SUBJECT:
Foundation Report
State Route 41 Bridge over Kings River
Bridge No. 45-0007
Kings County, California

**FOUNDATION REPORT
SR 41 BRIDGE OVER KINGS RIVER
BRIDGE NO. 45-0007
KINGS COUNTY, CALIFORNIA**

RESPONSE TO CALTRANS COMMENTS

Comment & Response Form

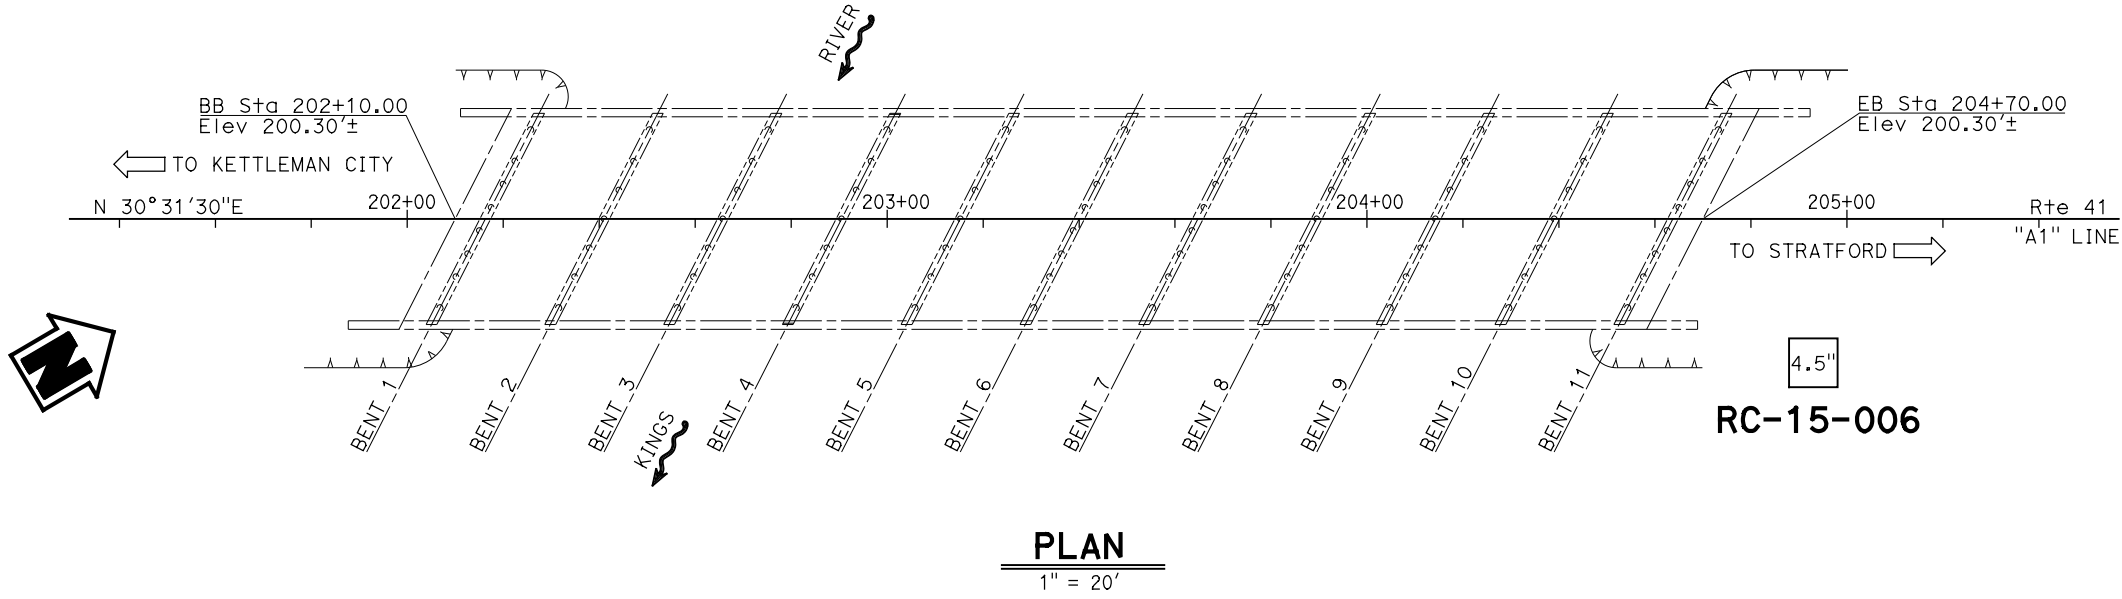
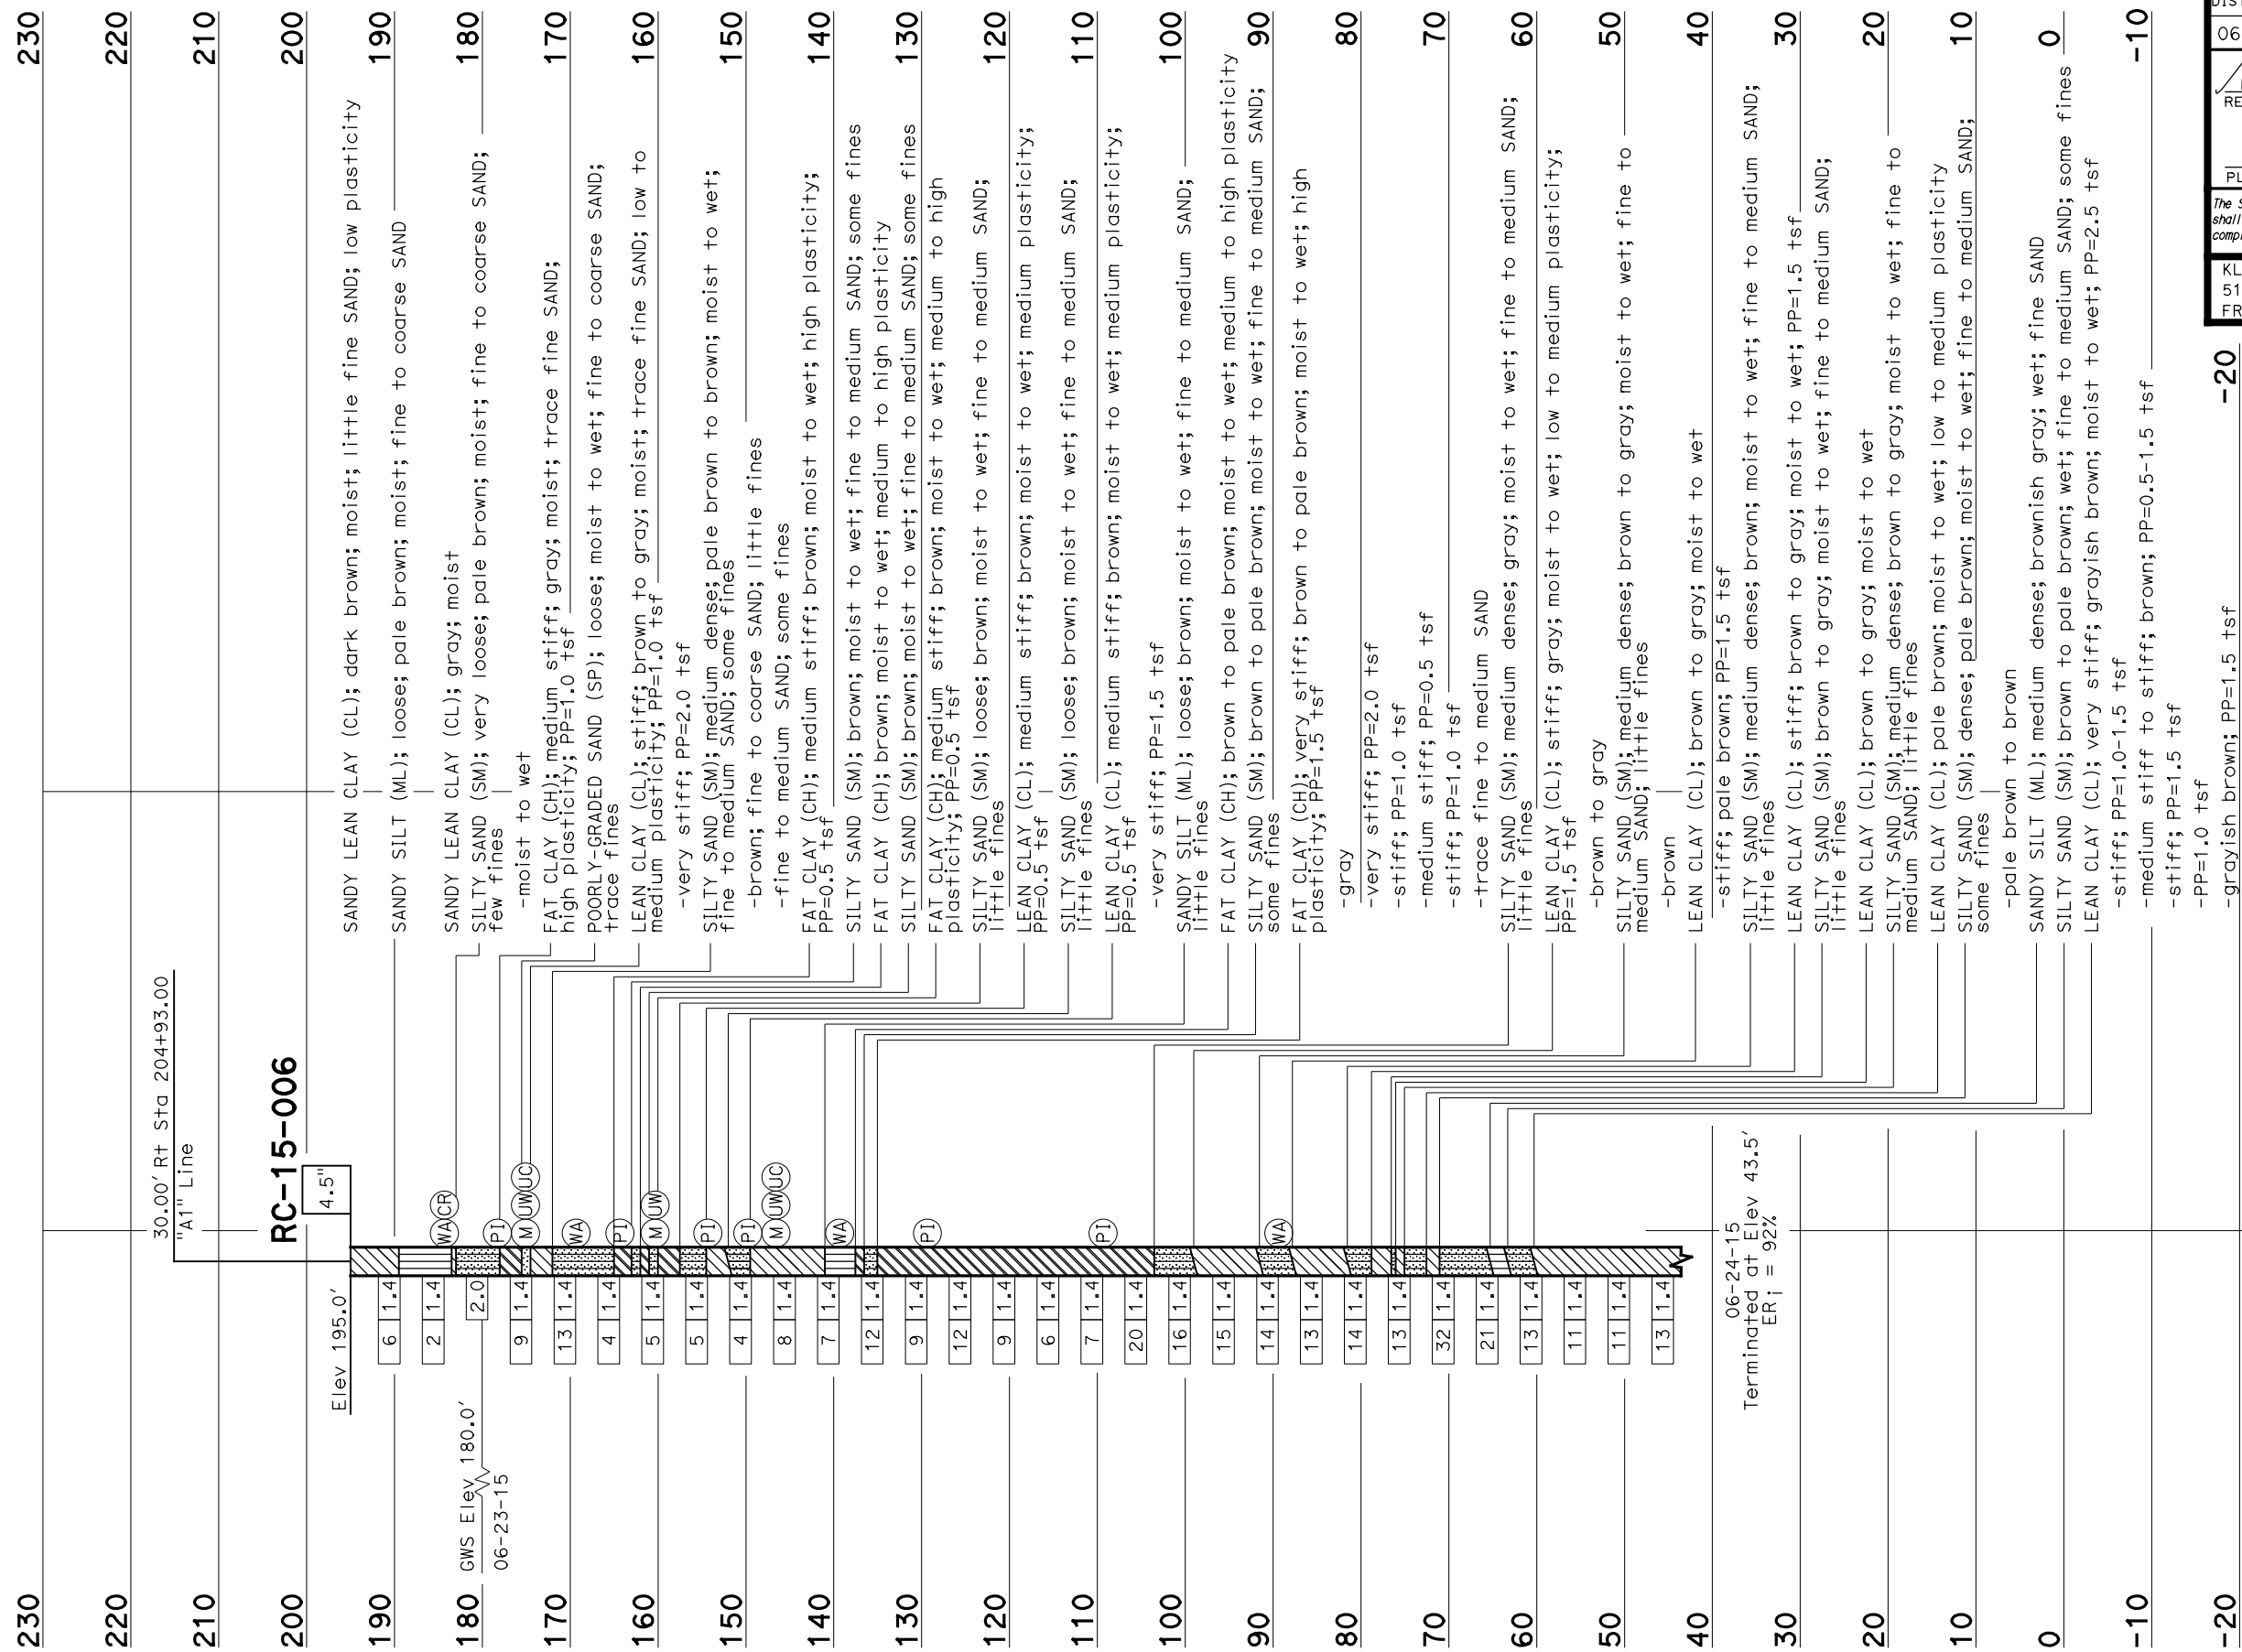
For clarification, tables for abutments and bents were added.	
6	FR	LOTB	Please follow Caltrans Soil and Rock Logging manual for format, thanks	The LOTB was prepared using the Caltrans Soil and Rock Logging manual, June 2010. Borings were very deep and contained too much information to be aligned vertically, and were rotated to fit the page and placed on separate pages, as permitted in the manual.	
7	Note		FR by Kleinfelder dated 09/03/15, managed through GS contract. Structure Design in house.		
8	Grade		C2 – conditional approval, subject to above comments addressed satisfactorily		
11					
12					
13					
14					
15					
16					
17					
18					
19					
20					
21					
22					
23					
24					
25					
26					
27					
28					
29					
30					
31					
32					
33					
34
